Access Compliance Report

Public Rights-of-Way

(Curb Ramps)

Intersection ID: 29165	Main Street: BOXELDER_LN	Cross Street: PURPLE_BLOOM_LN	Location: W
ADA ID: 1AF3B6F6ED8E	Ramp Type: PerpDiag	Initial Pass/Fail: Fail	Overall Compliance: No
Severity Score: 8.75			
Codes/Mitigation Info/Possible Solution		Field Measurements/Component Compliance

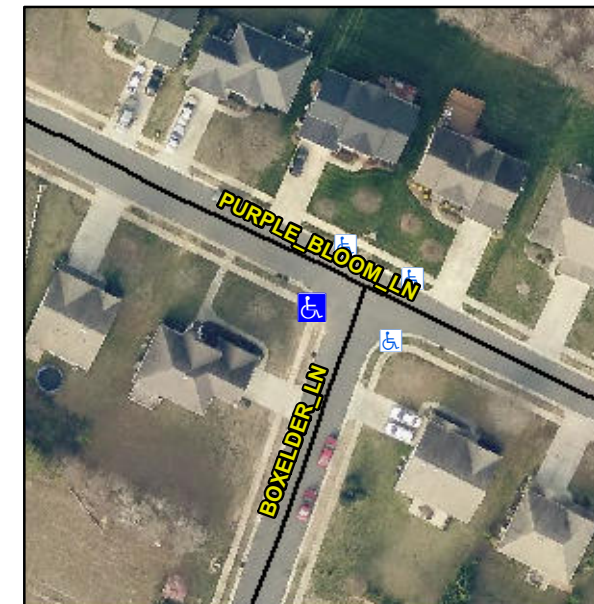
Remove & Replace Curb Ramp With Two New Directional Ramps or Equivalent.

R304.5.1

Compliance	Description	Data	Compliance	Description	Data
N/A	Ramp Length (in)	48.0	Yes	Ramp Slope (%)	8.0
No	Ramp Width (in)	38.0	Yes	Ramp XSlope (%)	1.0
N/A	Flare Type LT	N/A	N/A	Flare Type RT	N/A
N/A	Flare Slope LT (%)	N/A	N/A	Flare Slope RT (%)	N/A
N/A	Flare Traversable LT?	N/A	N/A	Flare Traversable RT?	N/A
N/A	Landing Length (in)	N/A	N/A	DWS Provided?	N/A
N/A	Landing Width (in)	N/A	N/A	DWS Contrast?	N/A
N/A	Landing Slope (%)	N/A	N/A	DWS Length (in)	N/A
N/A	Landing X Slope (%)	N/A	N/A	DWS Full Width?	N/A
N/A	Landing Curb? (Y/N)	N/A	N/A	DWS Offset (in)	N/A
N/A	Shared Landing?	N/A			
N/A	Gutter Ponding?	N/A	N/A	Gutter Slope (%)	N/A
N/A	Gutter Lip Ht (in)	N/A	N/A	Gutter X Slope (%)	N/A
N/A	Painted X Walk1?	No	N/A	Painted X Walk2?	No
	X Walk 1 Direction	To SE		X Walk 2 Direction	To NE
N/A	X Walk 1 Width (in)	N/A	N/A	X Walk 2 Width (in)	N/A
	X Walk 1 Slope (%)	0.5		X Walk 2 Slope (%)	1.3
	X Walk 1 X Slope (%)	0.1		X Walk 2 X Slope (%)	2.0
